**Site Plan Review Committee (SPRC)**  
**Staff Report for Wells Fargo/Verizon (3140**  
**Washington Blvd. & 1025 N. Irving St.)**

**Item 1. SPLN22-00002**  
**Wells Fargo/Verizon**  
(RPC# 19004012; 19004005; 19004011; 19004008)  
Planning Commission and County Board meetings to be determined.  
*Peter Schulz (CPHD Staff)*

**SPLN22-00002**  
**Wells Fargo/Verizon**  
(RPC# 19004012; 19004005; 19004011; 19004008)

Figure 6-- Courtesy Applicant

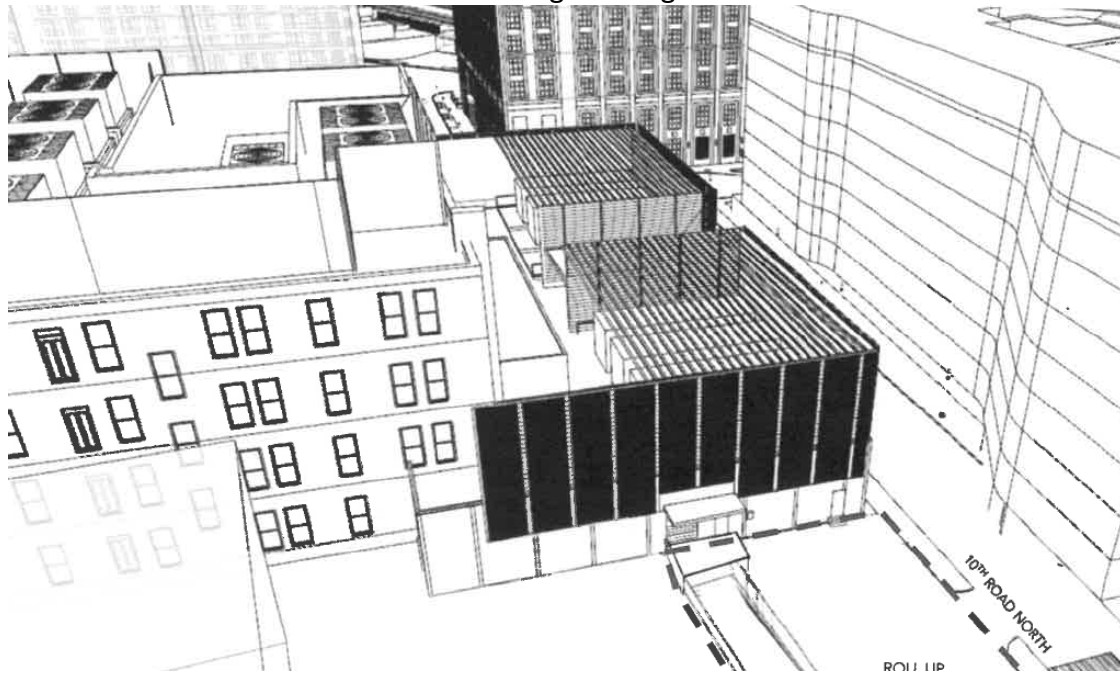
- Architecture/Urban Design: The developer and Verizon propose mechanical screening on the Verizon building. Staff would like to see other aesthetic improvements to the one-story, windowless 1970s Verizon addition.

- Architecture/Urban Design: Mechanical screening needs to be set back an equivalent distance to its height from the edge of the roof.
- Public Space/Landscaping: The proposed 10<sup>th</sup> Road North streetscape does not comply with the Zoning Ordinance requirements and good urban design practice—there are no street trees, an inconsistent sidewalk width, and sidewalk “jogging” created by the desire for the drive through ATM.

**Verizon Building:** The existing building, built over the course of decades since the 1930s, has some historic and aesthetic value, especially in the main four-story building block. While the building will remain, the developer and Verizon plan to work together to screen the existing emergency generators on the one-story 1970s façade. (Verizon also has plans to add rooftop mechanical equipment in the future and propose to screen them similarly.) Staff also has been encouraging the parties to examine improving the architecture of the windowless 1970s addition.

Figure 8-- 10th Road civil Plans

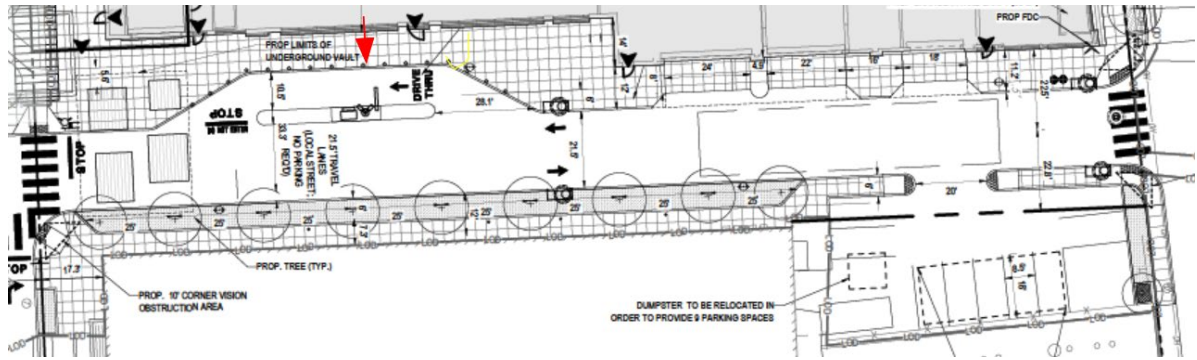
- Transportation: The presence of the drive-through creates a sub-optimal experience for pedestrians on the North Side of 10<sup>th</sup> Road, including lack of street trees and a jog in the path.

- Transportation: The Sector Plan envisions 10<sup>th</sup> Road as a local street with parking on at least one side of the street. Currently 10<sup>th</sup> Road looks more like an alley.

**Streetscapes:** ACZO Section 9.2 has detailed streetscape requirements for all frontages (see Section 9.2.3 Table 1 and Section 9.2.9 Map 5). The developer is generally compliant with the streetscape requirements, except for 10<sup>th</sup> Road North. The Zoning Ordinance requires a 12 foot sidewalk, with a six foot clear zone. Street trees are to be planted in minimum 5' X 12' tree pits, spaced approximately 30' on center (subject to adjustments for light pole location). The developer does not meet these requirements on either side of 10<sup>th</sup> Road North. On the south side, it is generally because of the desire to keep surface parking for Verizon, on the north side, it is caused by Wells Fargo's desire for a drive through ATM. On both sides of 10<sup>th</sup> Road, the sidewalk "jogs" in order to accommodate these desired uses. Jogs are generally discouraged in more urban public sidewalks, although 10<sup>th</sup> Street will generally be a less travelled street by pedestrians than the other surrounding frontages.

Figure 9-- Irving Street stepback

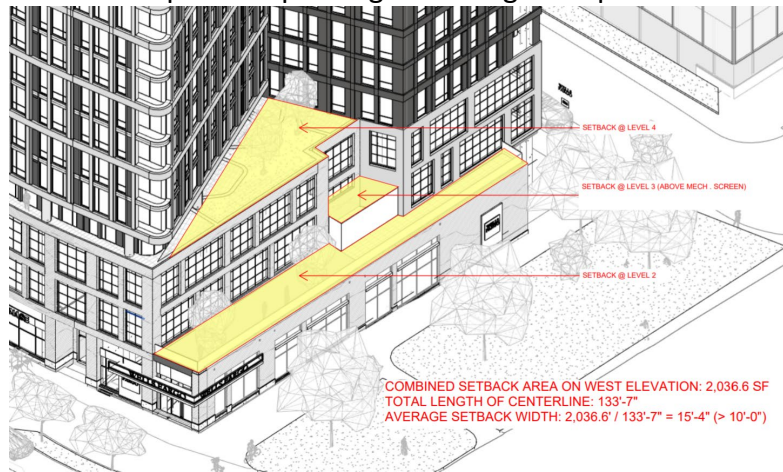
Stepback: One building stepback of 10 feet is required on Irving Street on the on the second, third, fourth or fifth floor. The developer is requesting an averaged stepback as shown below:
